**Subject: Sacramento Regional County Sanitation District  
Comments on the Tentative Waste Discharge  
Requirement for the Sacramento Regional Wastewater  
Treatment Plant**

### Regional San Comments on the Tentative Draft of the WDR and MRP

SUBJECT: **EVALUATION OF MONITORING WELLS AND PROPOSED LIST OF WELLS FOR REMOVAL FROM THE MONITORING AND REPORTING PROGRAM**

**Figure 6**  
**Current Monitoring Well Network**  
**Wells in Unit D**

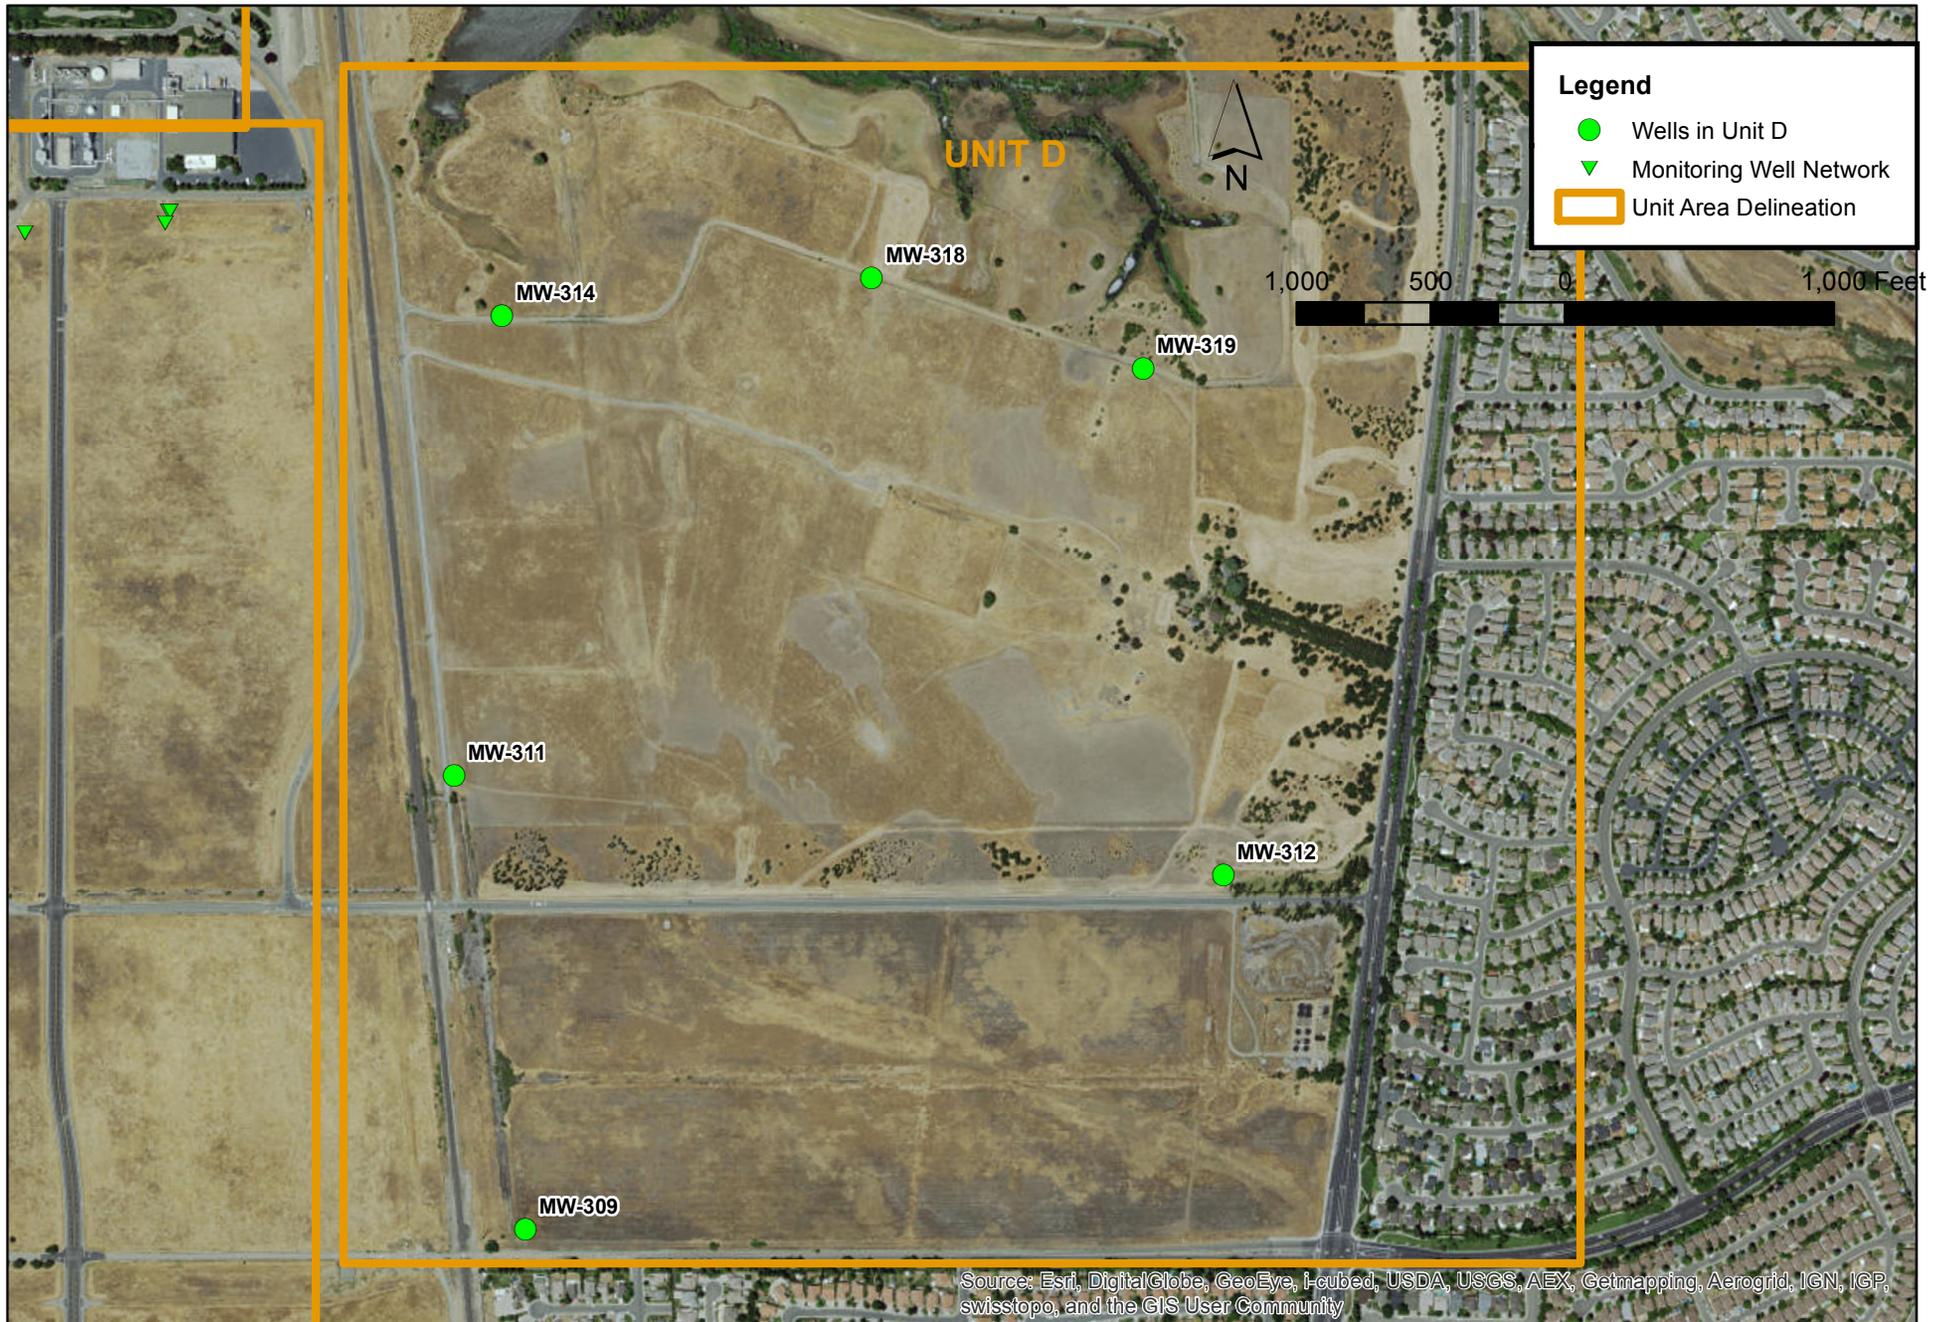
There are no proximal well pairings in Unit D as seen in **Figure 6**.
